IS-NT-AFR

Air Fuel Ratio controller for Lean burn systems with SPI, SPtM, MINT

SW version 2.6.4

Image 2.1 Heartbeat signal configured to HeartCheck function

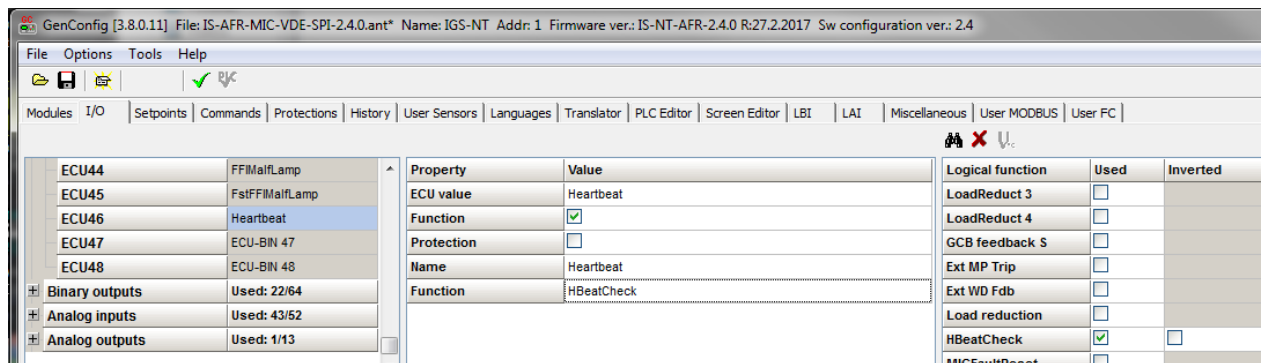
- Support for J1939 protocol from MIC ignition added. It includes also possibility to Reset MIC from controller
- Datalogger heartbeat check – There is BIN from Datalogger in ECU values called Heartbeat. This BIN is automatically configured as input to new HBeatChek function. Output from this function is new LBO HBeatError, this LBO is activated when Heartbeat signal from datalogger is not cycling or cycling slowly. If needed Shutdown can be activated based on this signal. Warning is issued automatically when Heartbeat signal from datalogger is not cycling or cycling slowly.

Image 2.2 Datalogger configured in ECU list

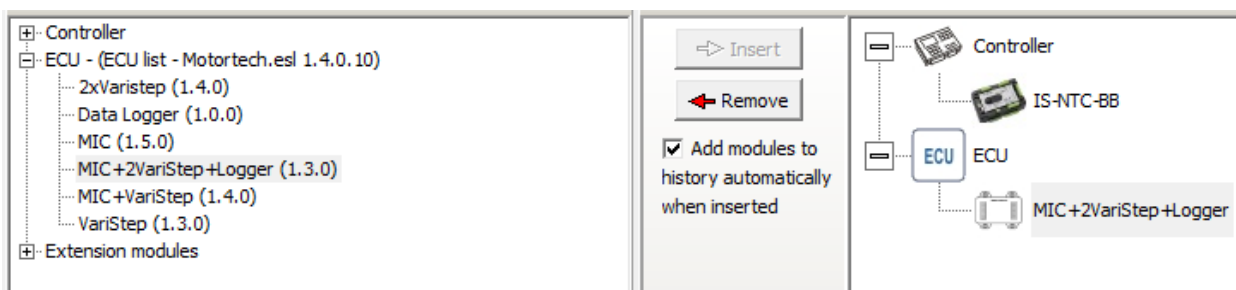
- This version includes ECUList Motortech version 1.4.0.10 where support for communication to Datalogger has been added
